APPEAL SUMMARY

Appeal ID: 21962	Project Address: 6704 SE 122nd Ave
Hearing Date: 10/2/19	Appellant Name: Jan-Philp Hollstrom
Case No.: E-001	Appellant Phone: 503-706-1520
Appeal Type: Electrical	Plans Examiner/Inspector: Brian Crise
Project Type: commercial	Stories: ? Occupancy: Not given Construction Type: Not given
Building/Business Name:	Fire Sprinklers: No
Appeal Involves: other: Ductbank cover depth	LUR or Permit Application No.: 19-233394-ET
Plan Submitted Option: pdf [File 1]	Proposed use: Pedestrian walking path

LEACH BOTANICAL GARDEN
 UPPER GARDEN DEVELOPMENT

A ASPHALT PAVING - TYPE 1
 NO SCALE

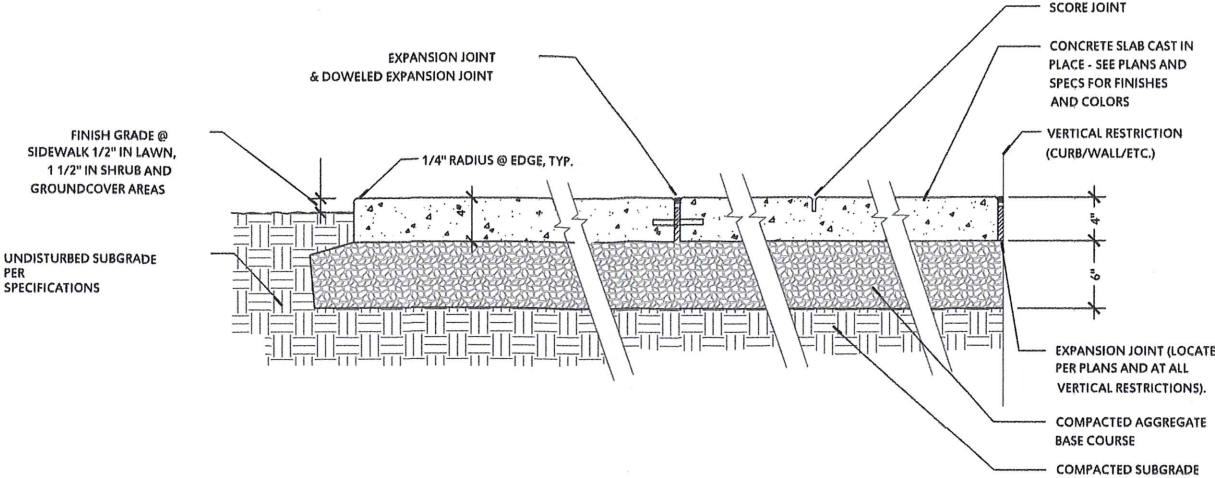
Code Section	NEC Table 300.5
Requires	Table 300.5 shows that PVC conduit may be covered with 4" of backfill, if below a 4" concrete slab with no vehicular traffic. The code is unclear as to required cover under asphalt, not subject to vehicular traffic.
Proposed Design	To install PVC conduit in the top layer of subgrade, scratched in, and covered with 4" of aggregate and 3" of asphalt, per detail D on C-402. Total cover on asphalt walkways would be 7-8" of asphalt, aggregate and subbase backfill. Please see affected walkway highlighted on C-310 and C-312.
Reason for alternative	Urban Forestry, a part of the City of Portland Parks and Recreation, opposes trenching to required depth as they fear it may damage tree roots in the botanical garden. The walking paths in this project are either concrete paved type 1 or 2 as shown on attached C-402, or asphalt paved type 1, also show on C-402. Table 300.5 allows us to install the 1" conduits (PVC sch. 40) on the subgrade and meet cover requirements for concrete walkways. The asphalt walkways do not appear to have sufficient cover to meet code, if installed on the subgrade.

Conduit cover depth below asphalt: Granted provided marker tape is used along route of conduit and provided the as-built plans clearly show the decreased cover depth.
